Title & Document Type: 8405A Vector Voltmeter Operating and Service Manual

Manual Part Number: 08405-90024

Revision Date: May 1971

VECTOR VOLTMETER 8405A

Figure 7-11(b). Schematic Diagram, Phase Meter

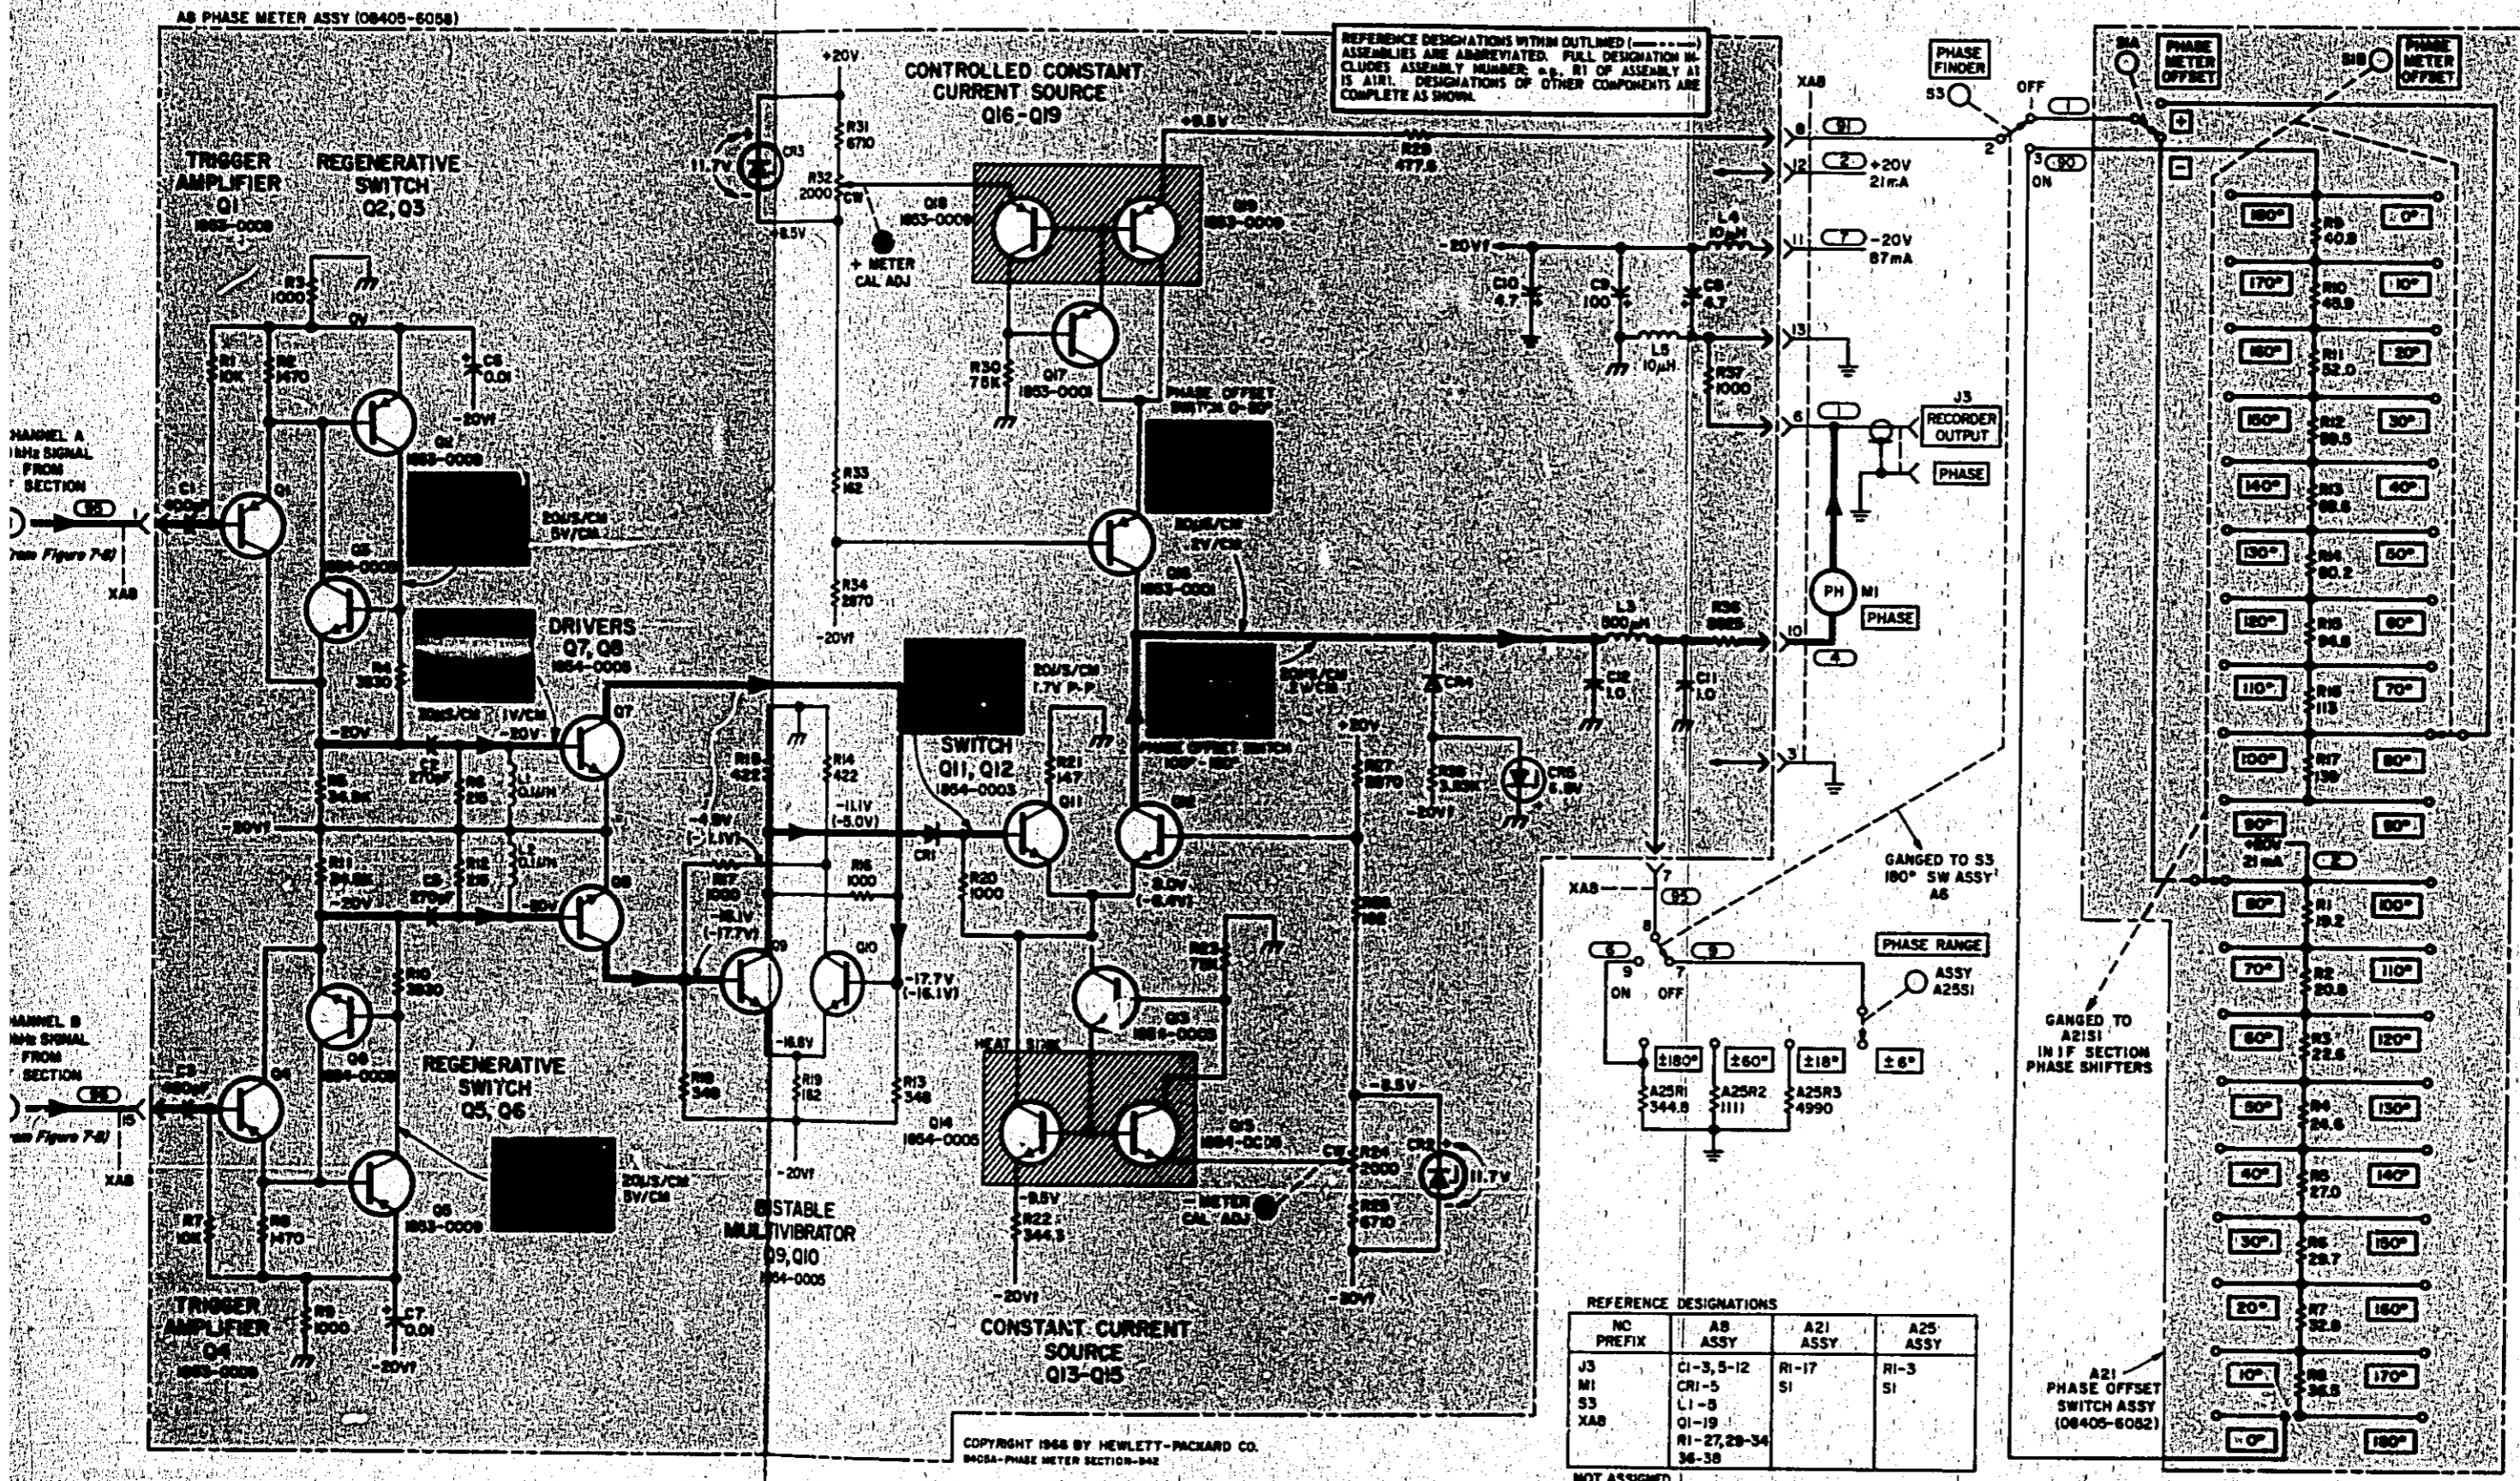
Change Figure 7-11(b) of Change 17. In the lower left corner of the replacement page, the A21 Phase Offset Switch Assy is identified as part number 08405-6052. Replace the part number with this note: See Table 6-1 for current assembly number.

Figure 7-12. Amplitude Range Switch Component Location

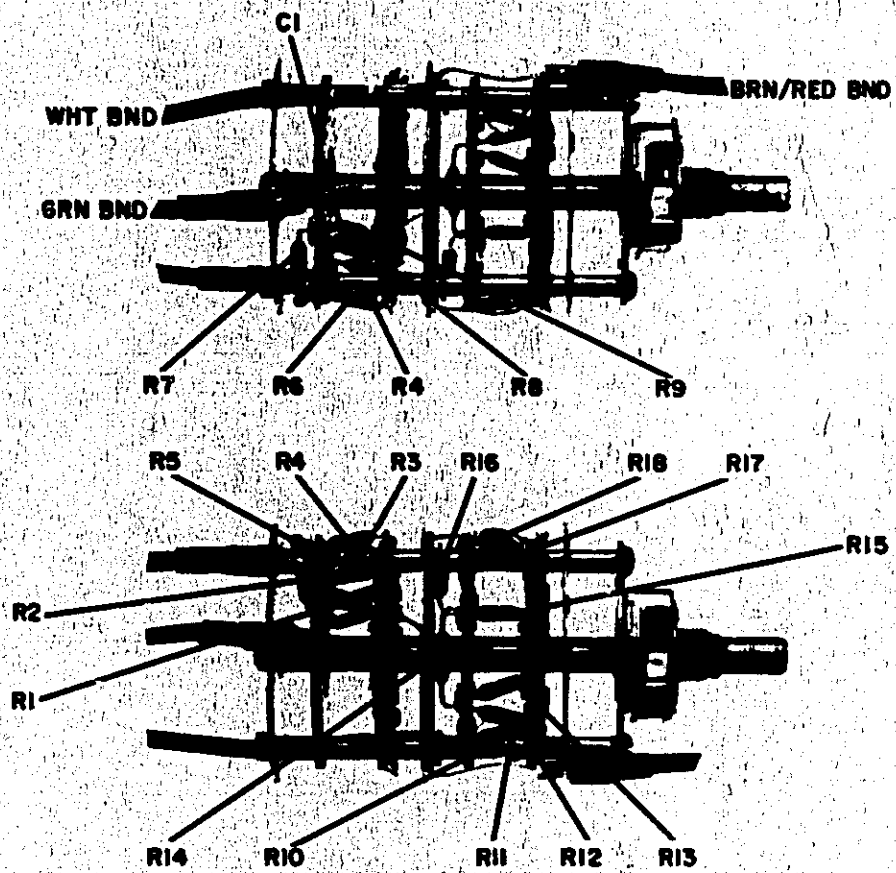
b.) To improve range to range tracking of the VOLTMETER, add capacitor A22C1 to A22 Amplitude Range Switch Assy (see Figures 7-12 and 7-13).

Figure 7-13(b). Schematic Diagram, Voltmeter

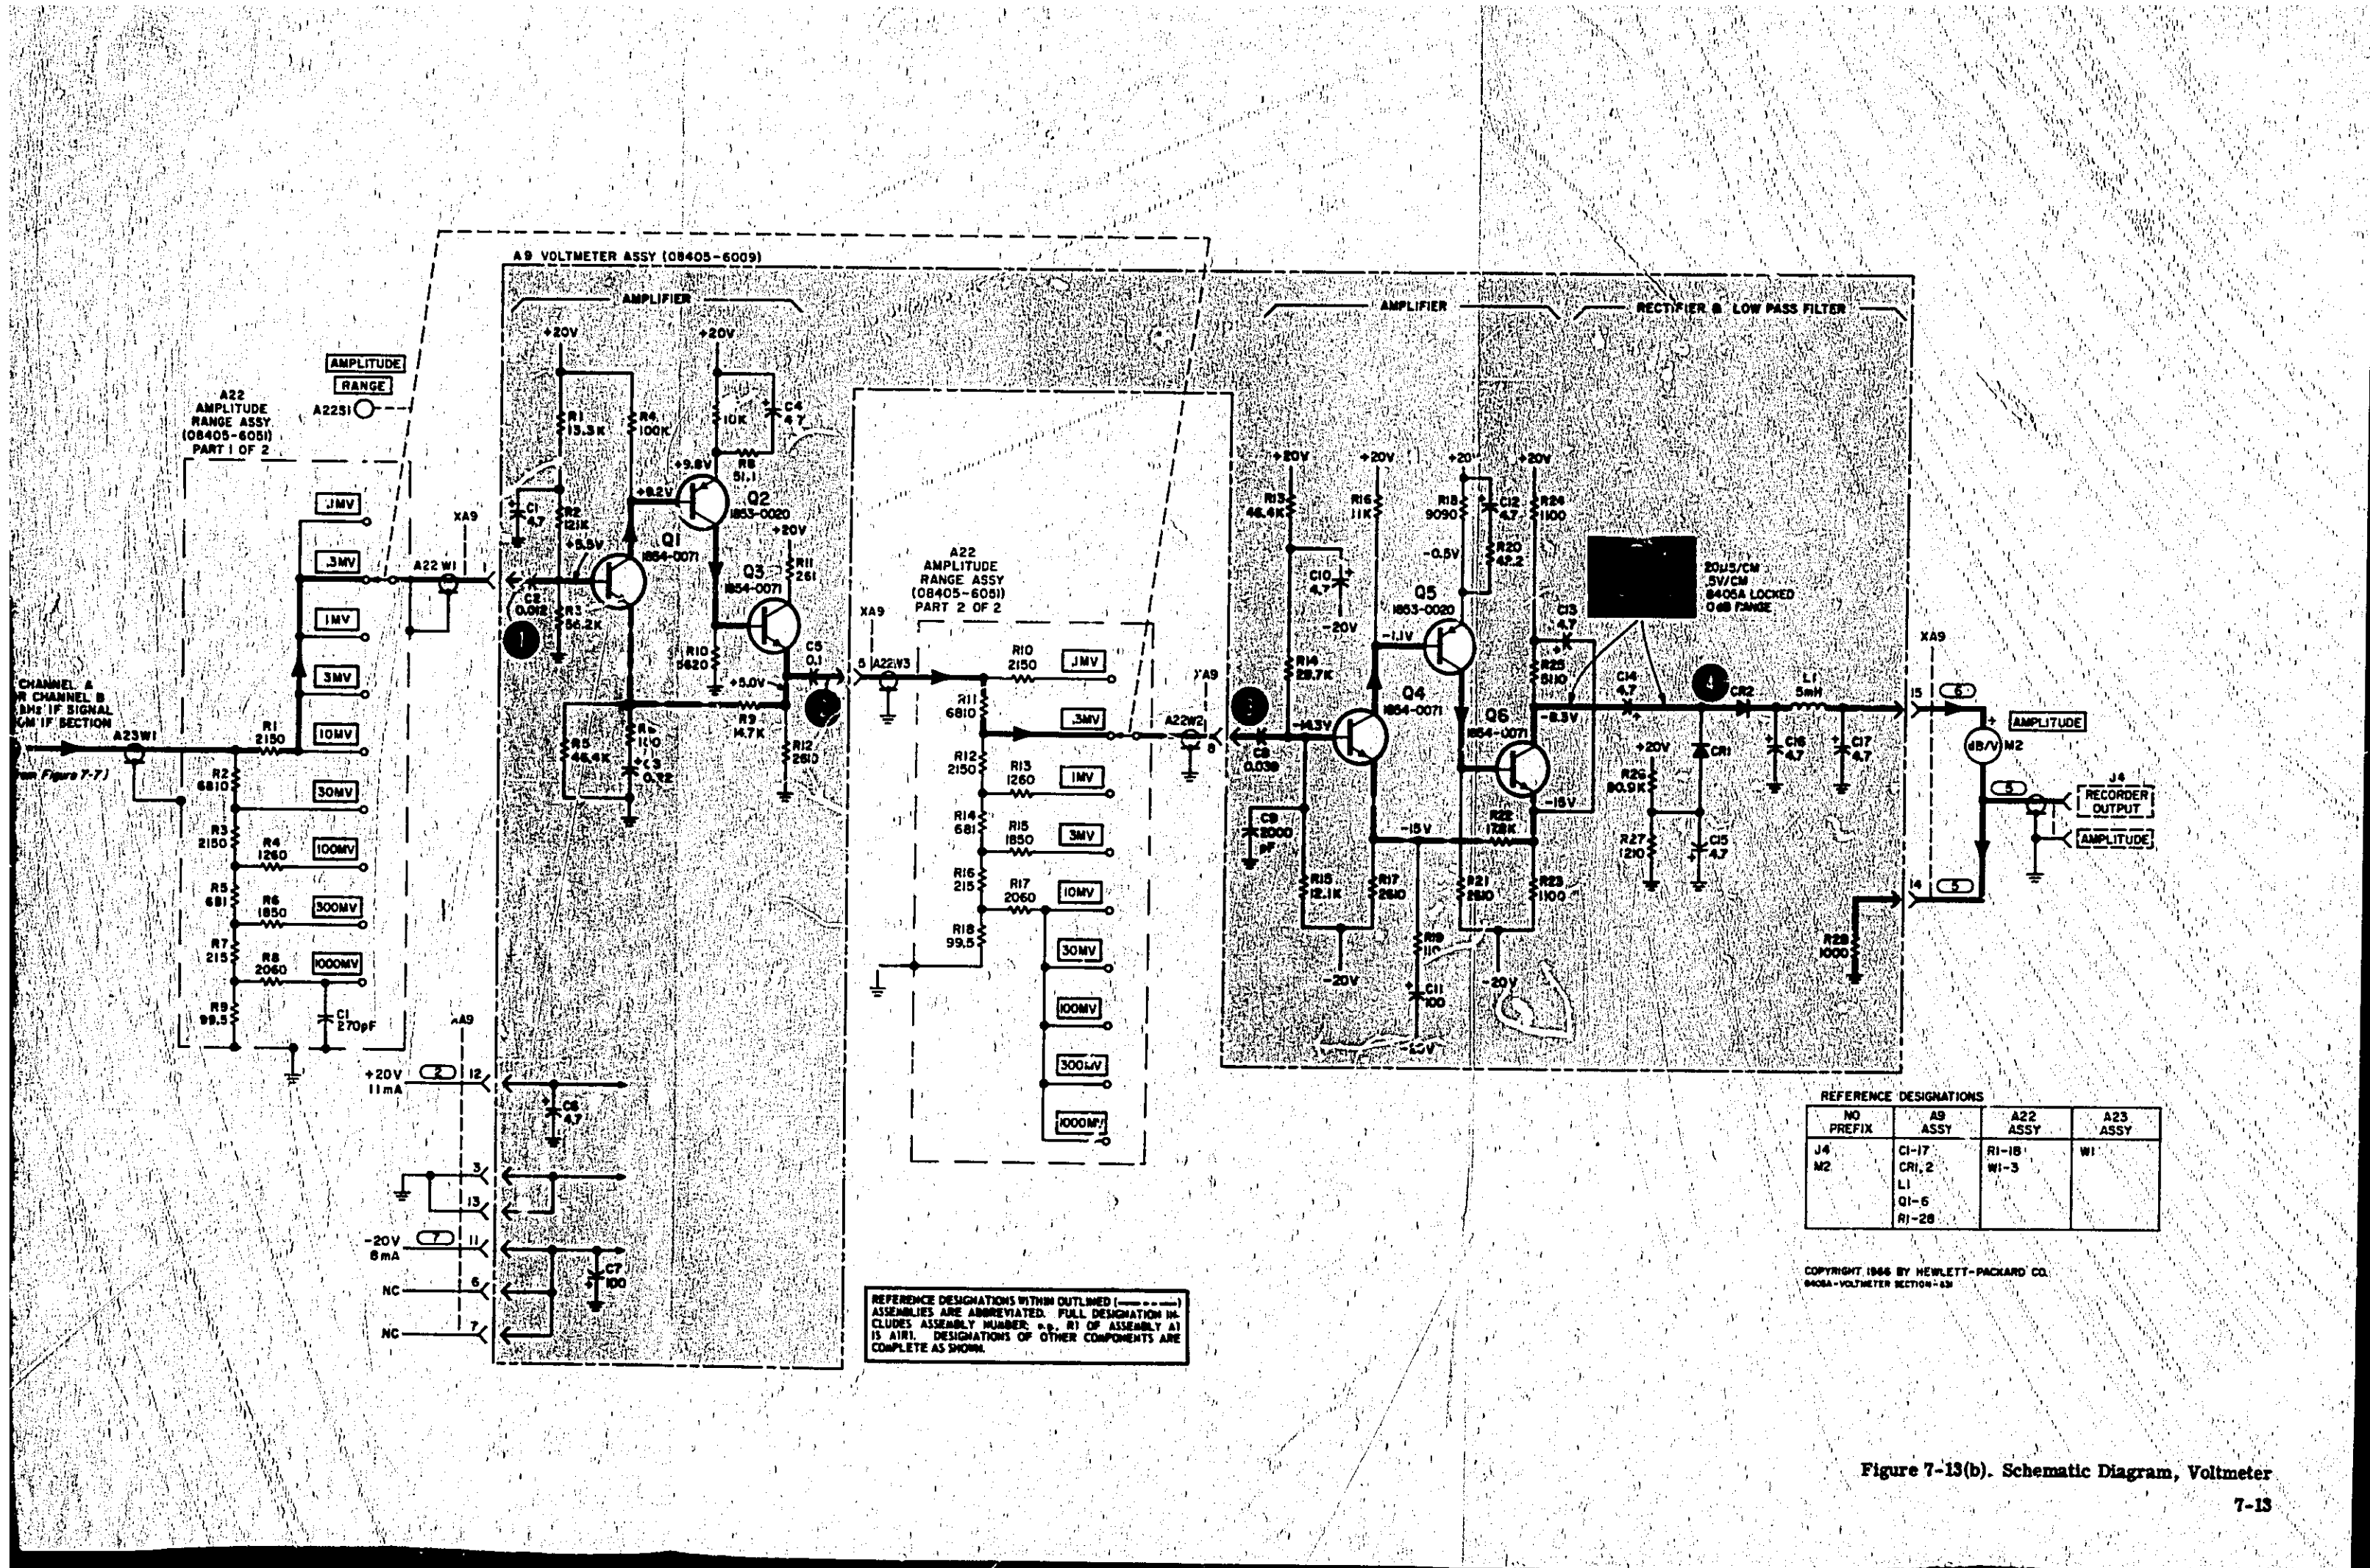
Change Figure 7-13(b) of Change 17. The A22 Amplitude Range Assy is identified twice as part number 08405-6051. Replace the part number with this note: See Table 6-1 for current assembly number.

Figure 7-16. Frequency Range Switch Component Location

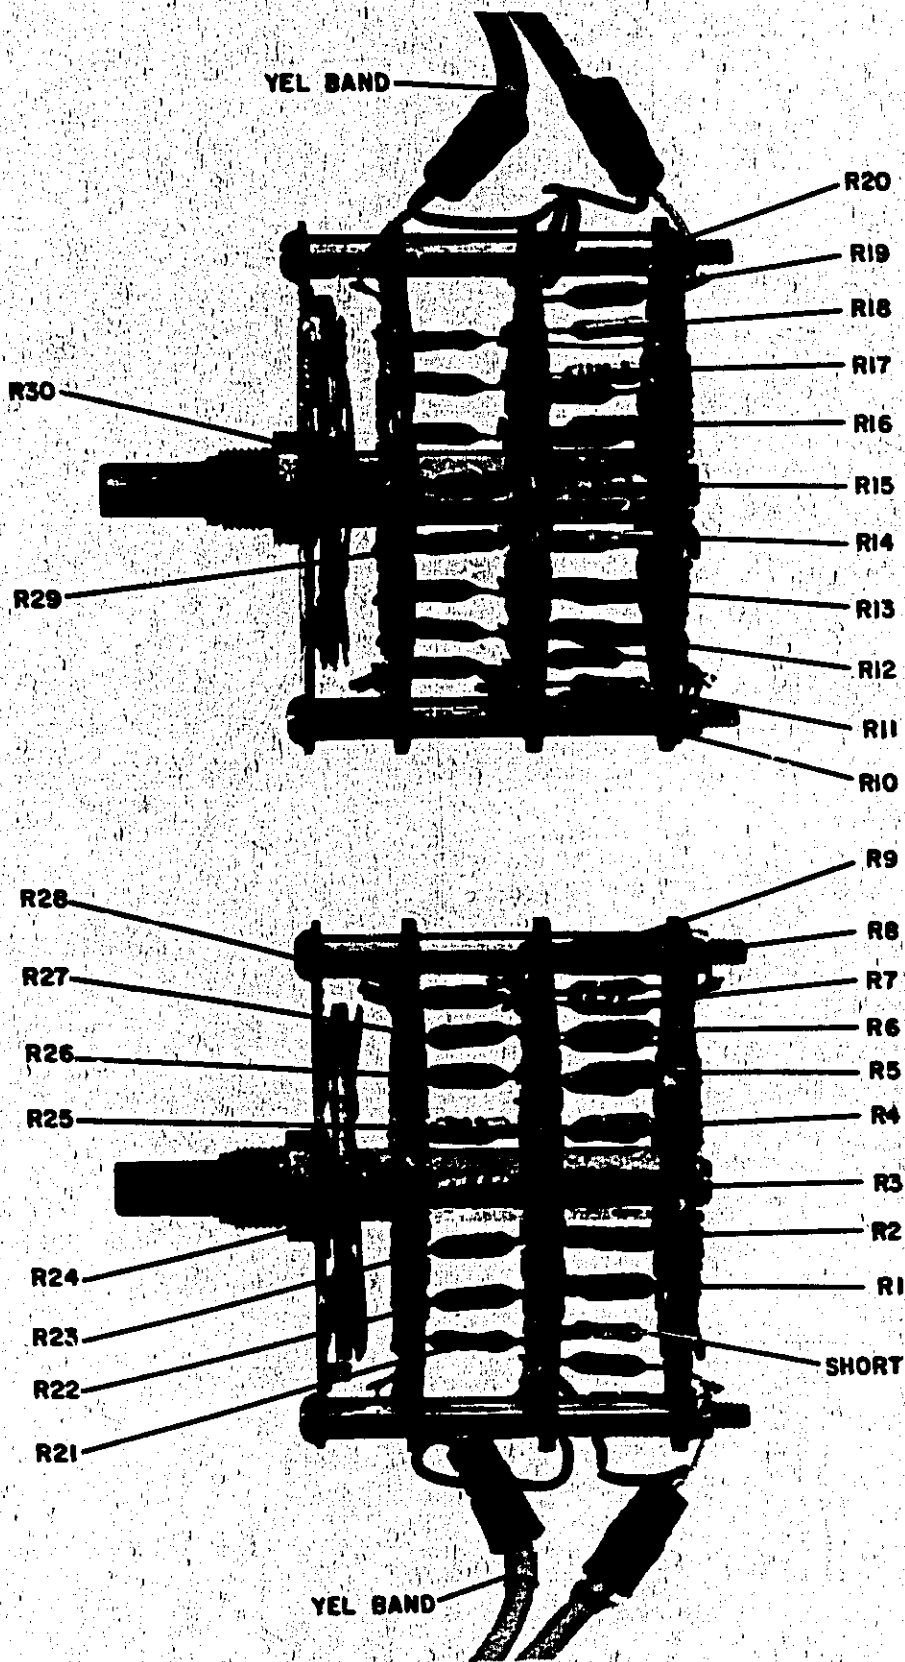
CHANGE 17: To improve performance of the A14 VTO Assy (08405-6014), it is recommended that resistors A14R23 and R4 be added. R4 is to be inserted between pin 9 of XA14 and wiper A of A24 Frequency Range Switch Assy (see Figures 7-16 and 7-17).

Figure 1. Partial Schematic of AB Phase Meter Assy (08405-6008)

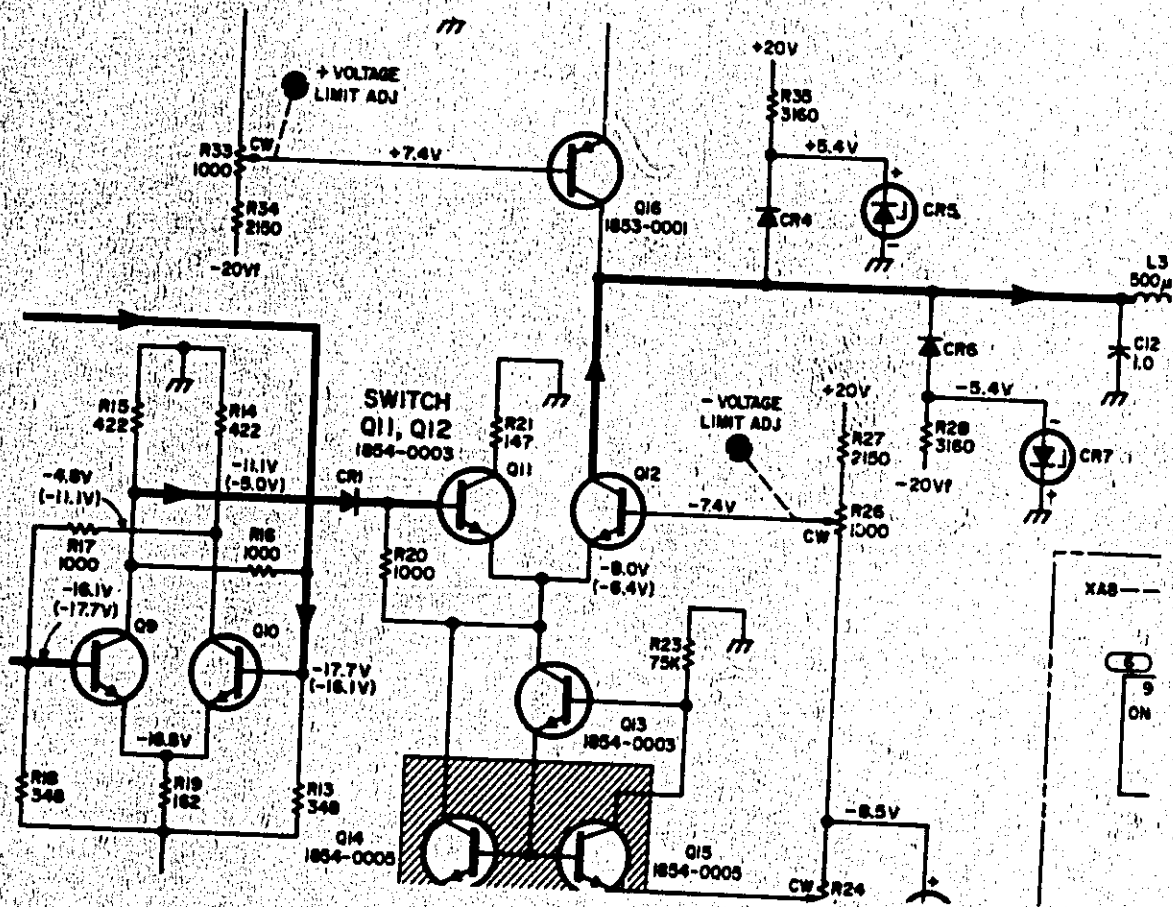
CHANGE 9: AB Phase Meter Assy is different (see Figure 1 below) than shown in Figure 7-11.

Change Resistors ABR27, R34,

To: 0698-0084 R:FXD MET FLM 2.15K OHM 1% 1/8 W
 From: 0698-3101 R:FXD MET FLM 2.87K OHM 1% 1/2 W
